UNITED STATES PATENT AND TRADEMARK OFFICE

APPLICATION NO.	FILING DATE	FIRST NAMED INVENTOR	ATTORNEY DOCKET NO.	CONFIRMATION NO.
09/847,901	05/02/2001	Masajiro Inoue	SIW-008	7510

Office Action Summary	Application No. 09/847,901	Applicant(s) INOUE ET AL.	
	Examiner Raymond Alejandro	Art Unit 1745

DETAILED ACTION

FIG. 3

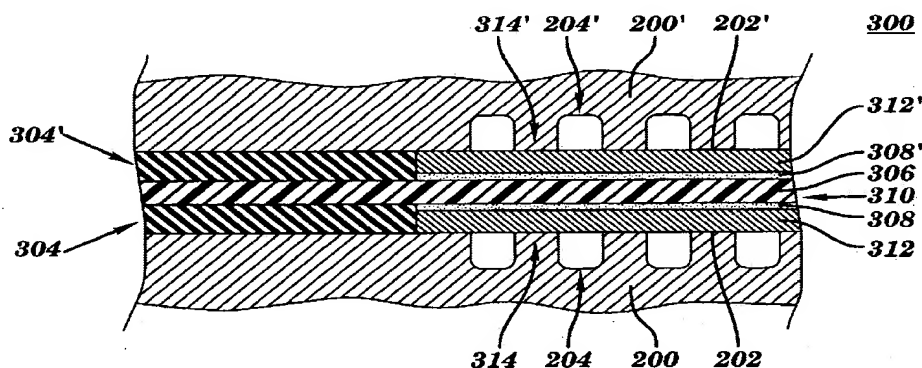
As seen in Figure 3, fuel cell 300 includes the membrane electrode assembly (MEA) 310 comprising a solid polymer electrolyte 306, catalyst 308 and 308' which facilitate chemical reaction are applied to the anode and cathode sides, respectively of the solid polymer electrolyte. This unit can be referred to as a membrane electrode assembly (col 6, line 56 to col 7, line 4). The MEA is sandwiched between anode and cathode gas diffusion layers 312 and 312', respectively (col 7, lines 5-8).

Jones discloses that gasketing material or gaskets 304, 304' can be employed to seal peripheral holes. A given gasket might take the form of, for instance, a frame gasket made from polytetrafluoroethylene material (col 6, lines 34-42). As depicted in Figure 3, the gasketing material 304, 304' contacts the end faces of both gas diffusion layers 312 and 312'.

As illustrated in Figure 3, the edge of solid polymer membrane 306 extends beyond (extended/projecting portion) the end faces of the anode and cathode side; and the gasketing material 304, 304' contacts the extended portion of the solid polymer electrolyte.

As depicted in Figure 3, the gasketing material 304, 304' contacts the end faces of both gas diffusion layers 312 and 312'.

As shown in Figure 3, the gasketing material 304, 304' contacts the end faces of both gas diffusion layers 312-catalyst 308 and gas diffusion layers 312'-catalyst 308' which are considered to be the anode and cathode electrode sides, respectively.

【 図 2 】

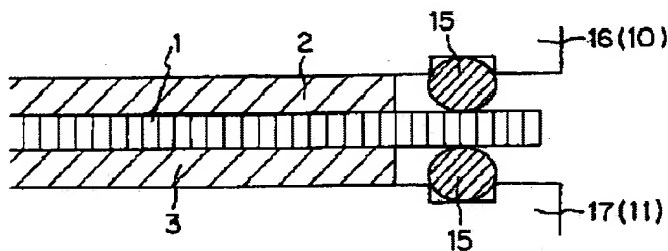
The JP'169 publication illustrates in Figure 2 a fuel cell structure including gas diffusion electrode wherein the separators 16, 17 provide grooves which are contacted and sealed by O-ring seals 15 (Figure 2 and section 0008).

In view of the above, it would have been obvious to one skilled in the art at the time the invention was made to seal Jones' separators by providing grooves thereon (*seal provided in grooves in the separator to seal them*) so as to obtain a seal-groove sealing structure as taught by
